Modification Recommended Service Note

Supersedes:
J7201B-01

J7201B Attenuation Control Unit, DC to 18 GHz, 0 to 121 dB, 1-dB Steps

Serial Numbers: MY59400001 to MY61410177

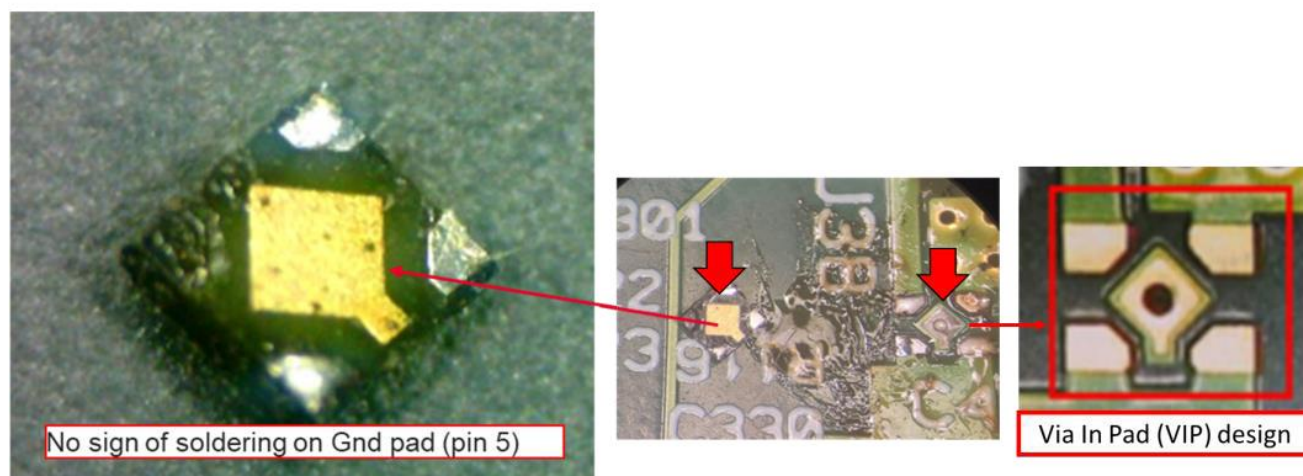
The instrument is unable to boot up and is stuck on the boot-up screen as follows. It is not functioning.

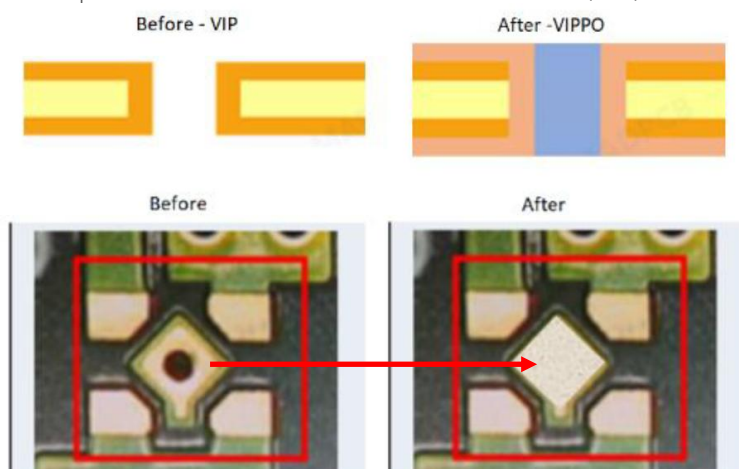
Failure analysis had indicated defective on P0600-63004 board where insufficient solder was observed at 2 locations. The insufficient solder was due to Via in Pad (VIP) where the melted solder had flown to the secondary side of the PCB.

The improvements were made from Via in Pad (VIP) to Via in Pad Plated Over (VIPPO) as per below.

The improved PPMC board have Serial number P06006300423**2413**000007 onwards.

Replace PPMC board P0600-63004 with Programmed PPMC board serial number P06006300423**2413**000007 onwards where 13 is the work week and 24 is the year.
